ADDENDUM NO. 3

DATE: July 26, 2010

Contract:10- C-00049; ARRA EECBG Energy Management System Installation at Old City Hall, Tampa Police Department Headquarters, Tampa Fire Rescue Headquarters

DRAWING TITLE: PARTIAL MECH/ELEC PLAN	DATE: 07-23-2010	JOB NO. 210010	REF. SHEET ME2.2.1	DRAWING NO. MESK-1
---	----------------------------	--------------------------	------------------------------	------------------------------

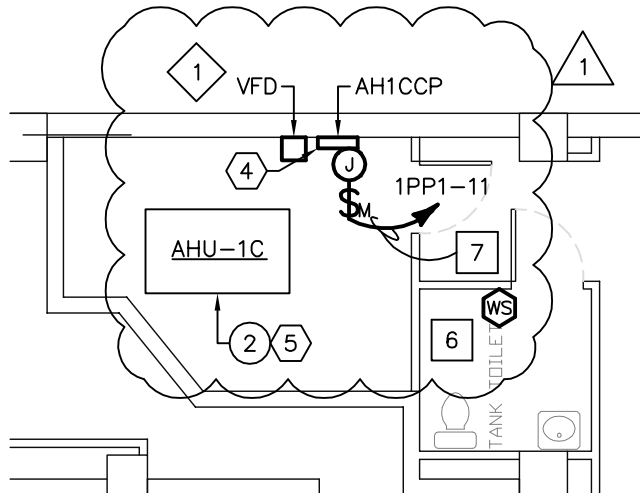
Item 2: Drawing, ME 2.2.1 revise: to add VFD to replace existing starter serving AHU-1C per sketch MESK-1, for the Tampa Police Department Headquarters

- EXISTING STARTER SERVING AHU-1C TO BE REPLACED WITH VFD. VFD IS PROVIDED BY CONTROL CONTRACTOR, ELECTRICAL CONTRACTOR TO INSTALL. DISCONNECT AND REMOVE EXISTING STARTER. WIRE VFD TO EXISTING CIRCUIT LEFT FROM REMOVAL OF STARTER. EXTEND (3)-#10 THWN CU. AND (1)-#10 CU. GROUNDING CONDUCTOR IN 1/2" CONDUIT AND MAKE FINAL TERMINATIONS AS REQUIRED.
